Smithsonian Institution

Revitalization of the Historic Core
CONSULTING PARTIES MEETING #8

November 30, 2022

COMMENT SUMMARY | COVER PLATE

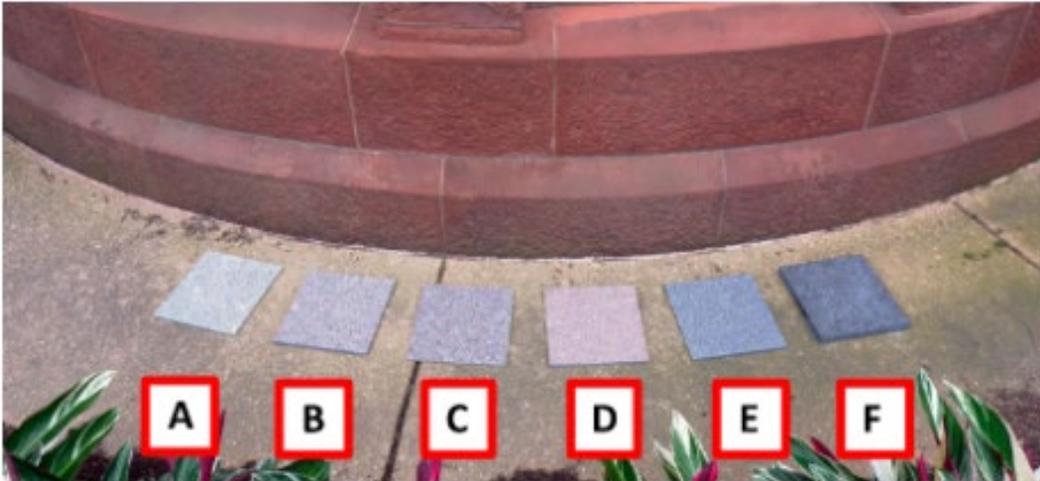
- Consensus that not adding the granite edge strip in front of the cover plate was better- "The smaller the insertion the better."
- Consensus that of the three gray range granite samples that "Virginia Mist" was the preferred option
- Concerns about the added width of the metal strip to provide a square edge for the granite insert

PERIMETER SECURITY ELEMENTS
 COMMENTS FROM CONSULTING PARTIES
 SEPTEMBER 7, 2022

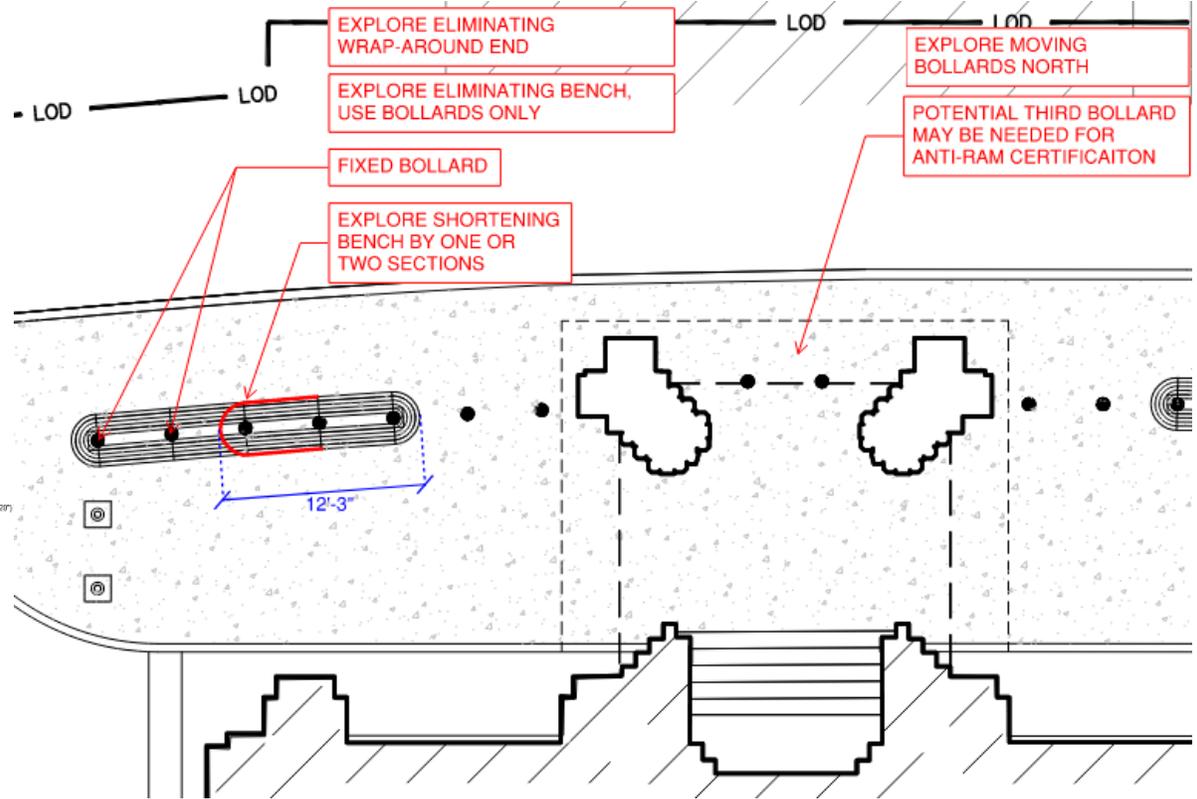
EXPLORE BENCH DESIGN WITHOUT A STONE BASE

NO WRAP-AROUND END, SHORTENED BENCH

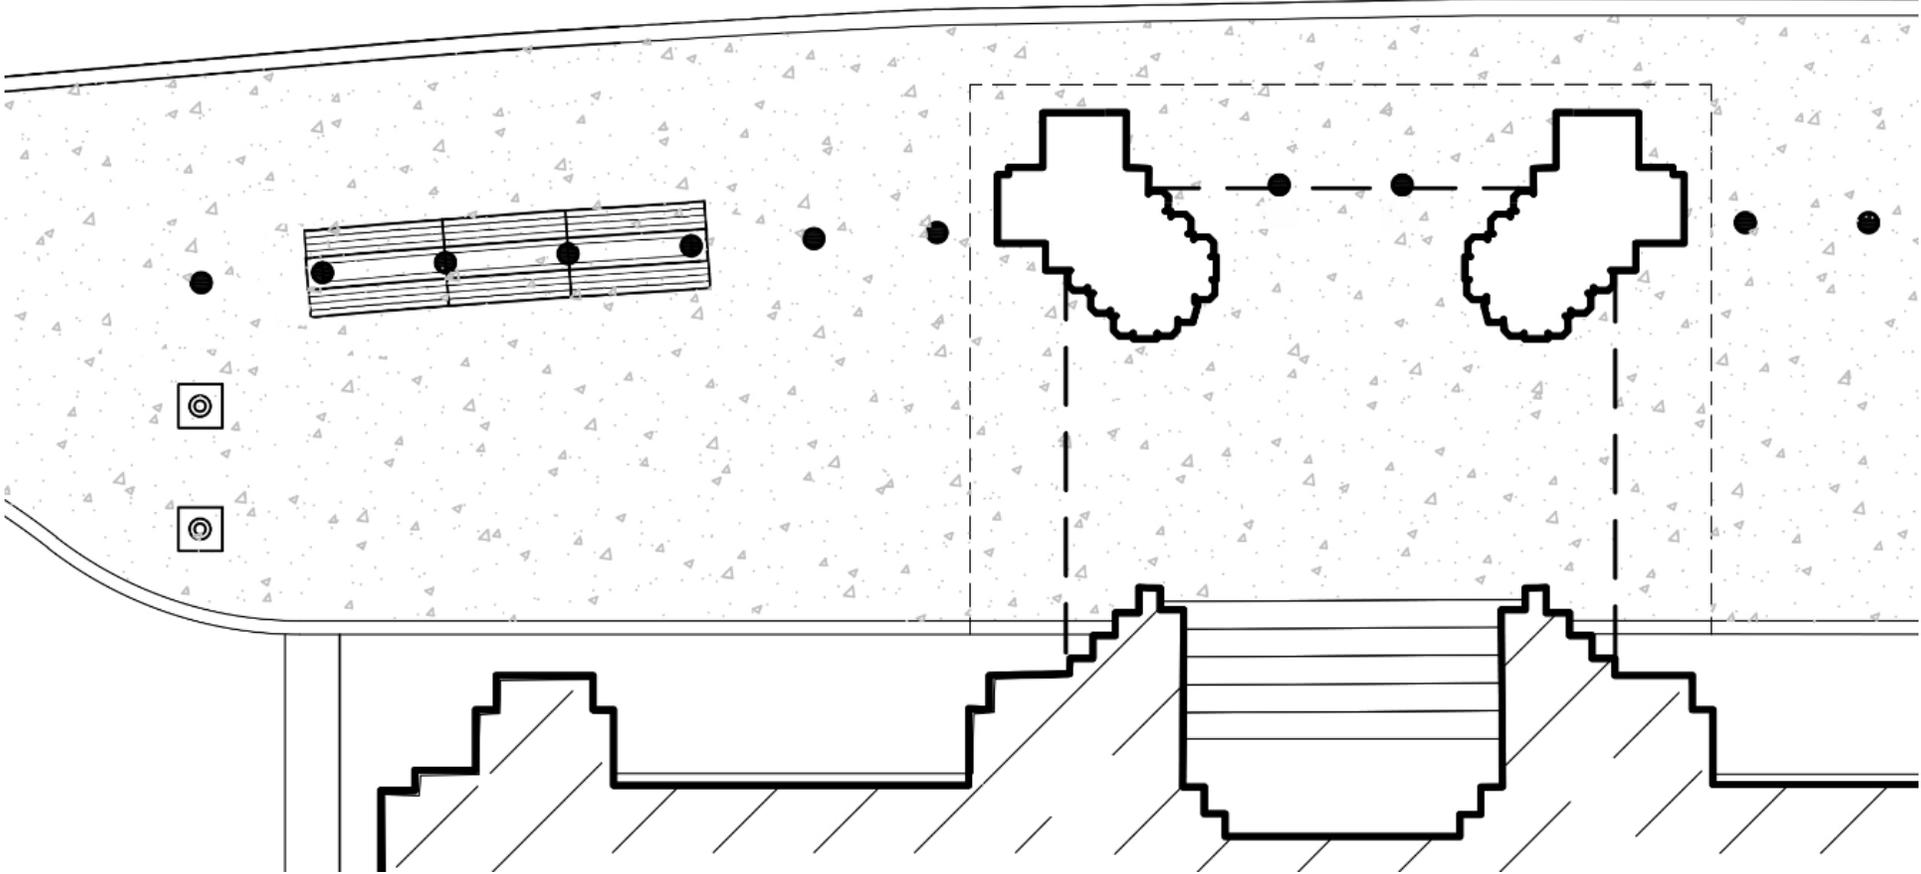
- Shortening the freestanding benches flanking the porte cochere to engage four bollards is preferred.
- Changing the end of the benches to a square end as opposed to rounded is preferred.
- Support the approach of adding a decorative end panel to the benches.
- As the bench is detailed further study of the height of the back is anticipated.
- Support the adjusted lengths of the benches to the east and west at the entry to the sloped sidewalks/ramps to the North Tower.

*Curb at lawn to be adjusted for seismic joint

PERIMETER AT JEFFERSON DRIVE

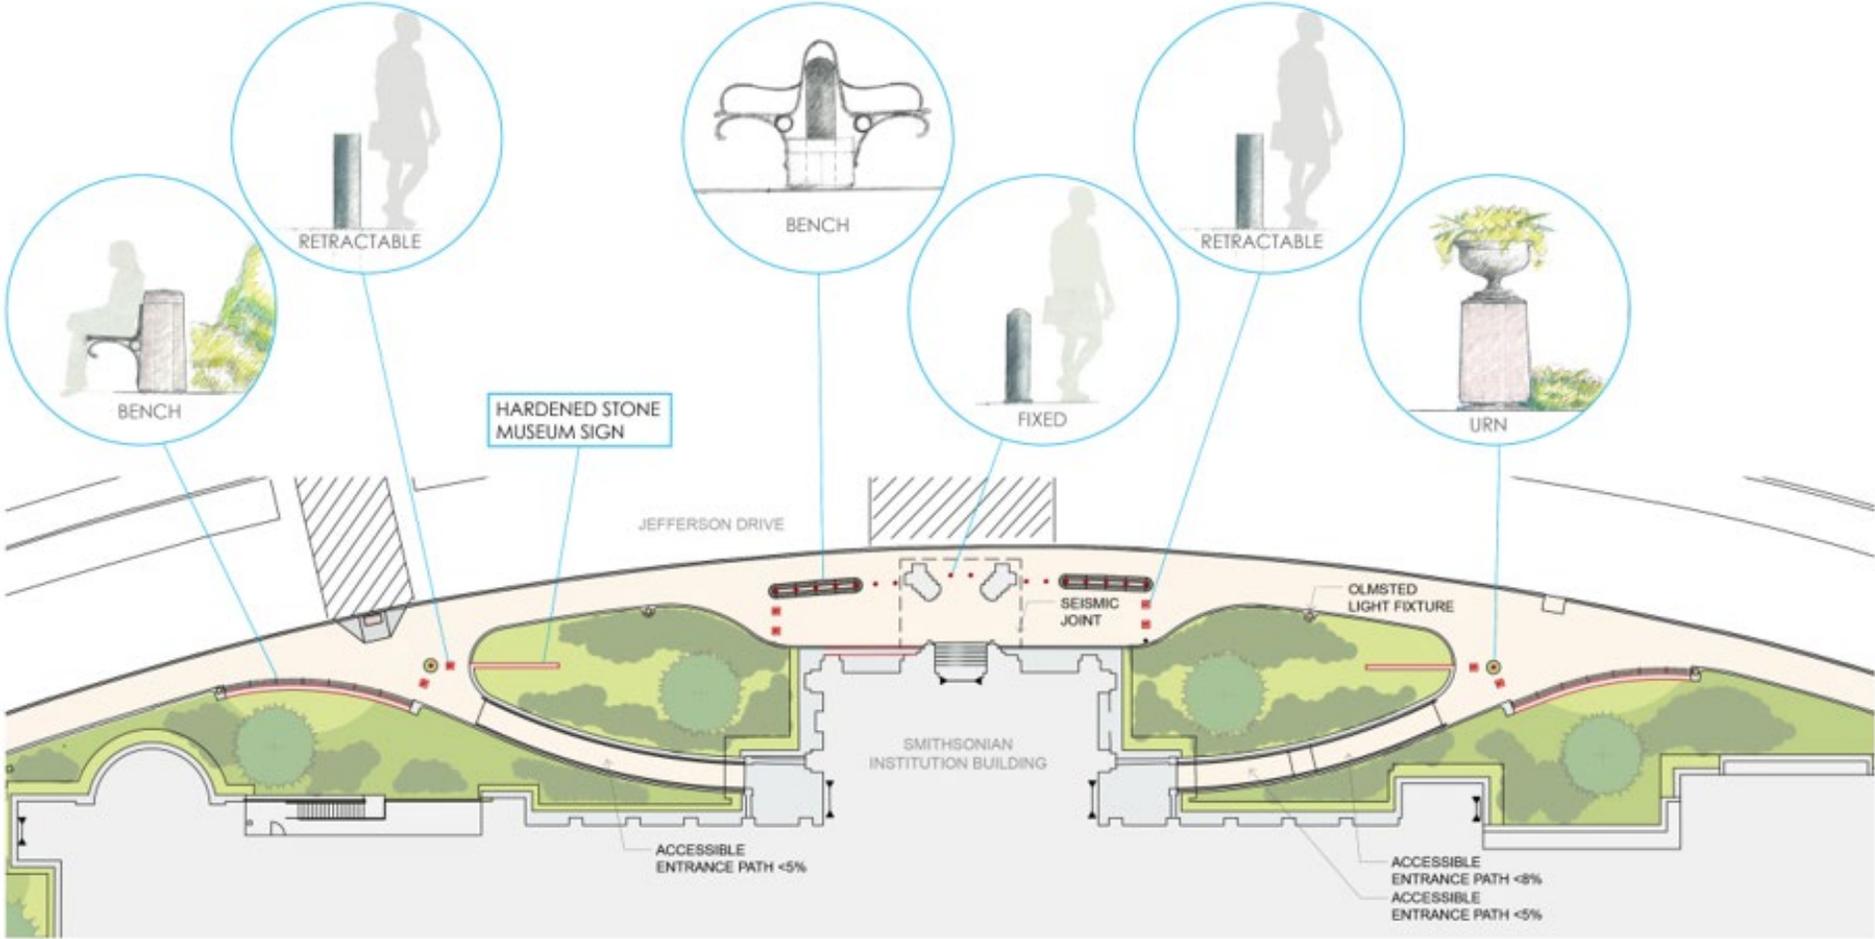
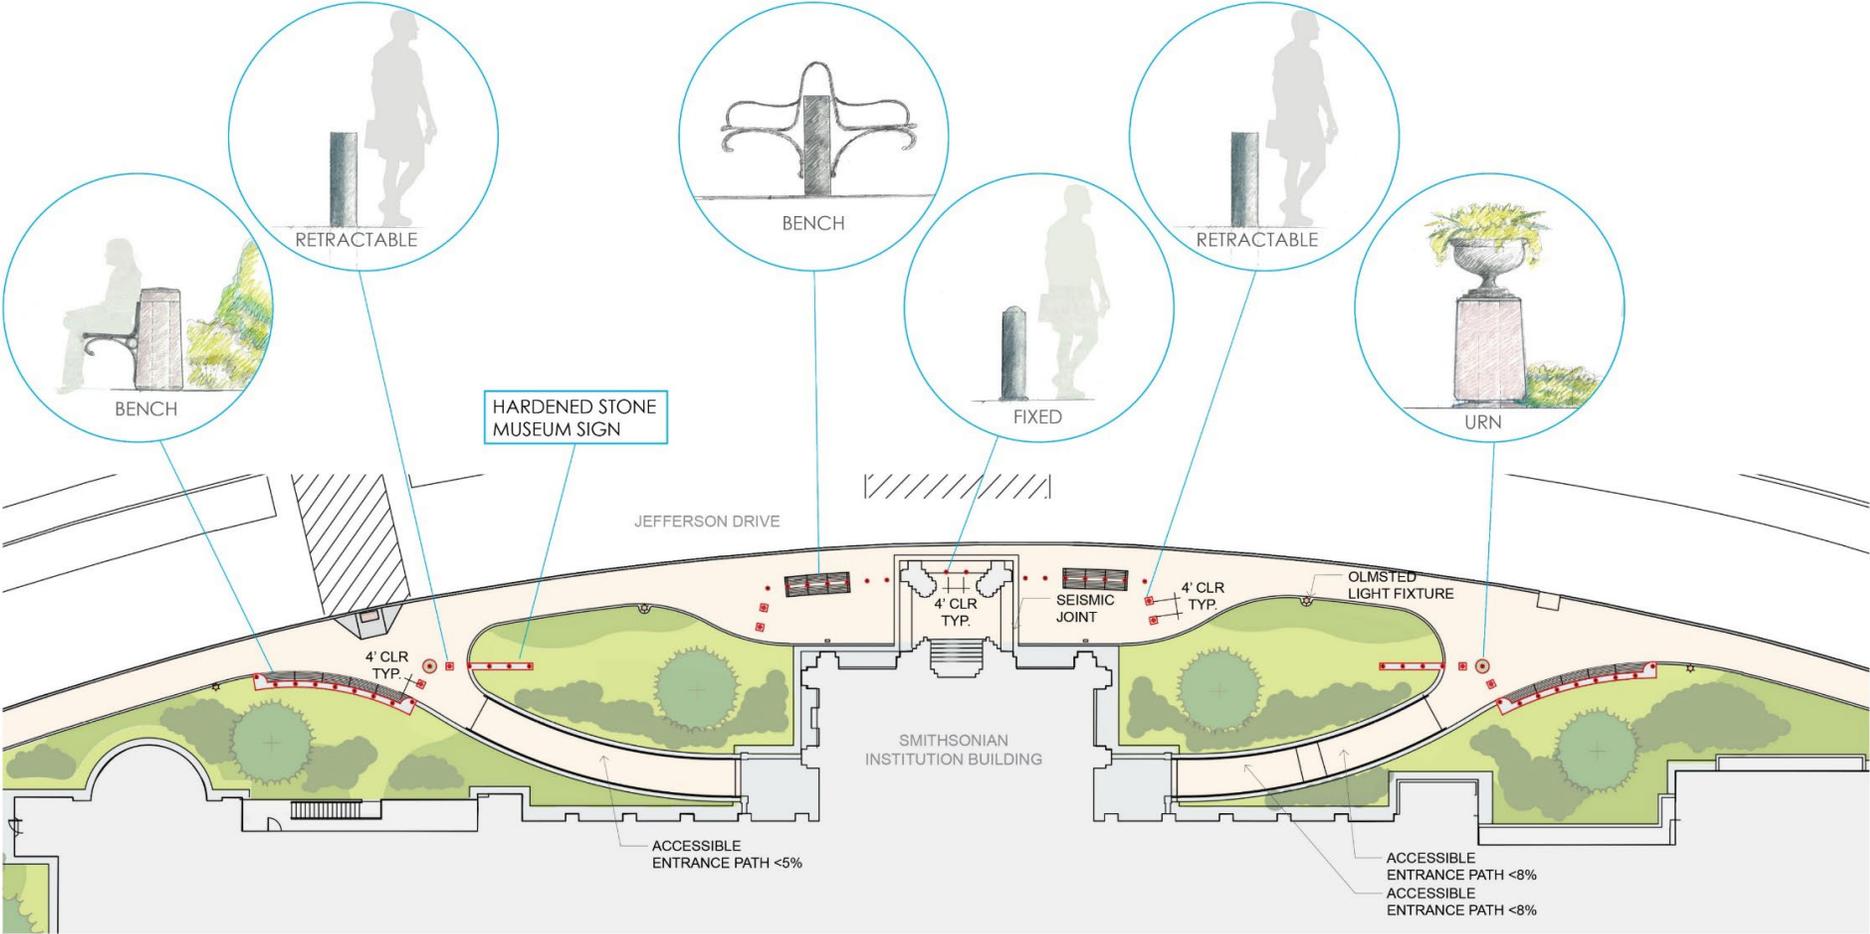
PREVIOUS DESIGN - CONSULTING PARTIES SITE VISIT
SEPTEMBER 7, 2022

PERIMETER AT JEFFERSON DRIVE
REVISED DESIGN - CONSULTING PARTIES MEETING 7
OCTOBER 26, 2022
